Pneumatic Hydraulic Jack Switch Cover Material Change Notification

Switch cover material change

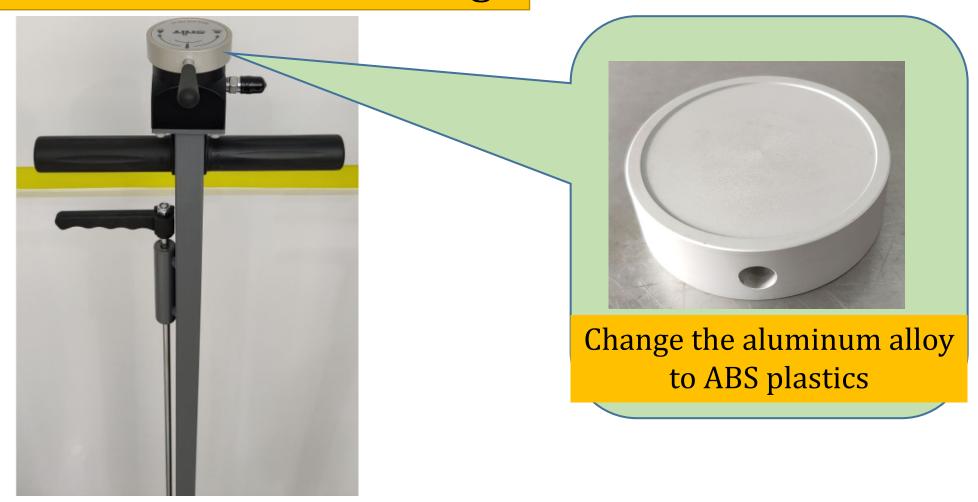
Some problems on switch cover surface treatment process

Switch cover surface treatment process for anodic oxidation, the process of treatment will produce a large number of pollution wastewater, the government is very strict on all kinds of environmental pollution control, has closed a large number of surface treatment process factories.

As the number of factories that can do anodizing has decreased dramatically, orders for products requiring this surface treatment process are bound to be concentrated in the few remaining surface treatment factories, leading to the following problems:

- 1. At present, the surface treatment price of the factory cooperating with our company has increased by more than 300%;
- 2. There are too many orders, the delivery cycle of surface treatment is also sharply delayed, and the delivery cycle is unstable, the longest delivery cycle even reached 200 days, which seriously affects the production cycle of our entire products, and inevitably affects the delivery cycle of our company to customers;
- 3. Even the factories that can do this kind of surface treatment technology at present are facing stricter environmental protection standards and requirements due to the green production and environmental regulation goals of the local government departments, and the production cycle in the future is also very unstable.

ABS material advantages

ABS material characteristics can replace aluminum alloy, the main advantages of the product are as follows:

- 1, ABS material is also very hard, wear resistance, impact resistance to meet the requirements of the product, and the size is stable;
- 2, ABS injection molding products, surface without any treatment, more environmental protection, and has been widely used in various industrial products;
- 3. There are many ABS factories with stable injection molding technology in our region, which can establish a stable supply relationship. Besides, the production cycle of parts is short, and the production cycle of some ABS products only takes about 10 days.
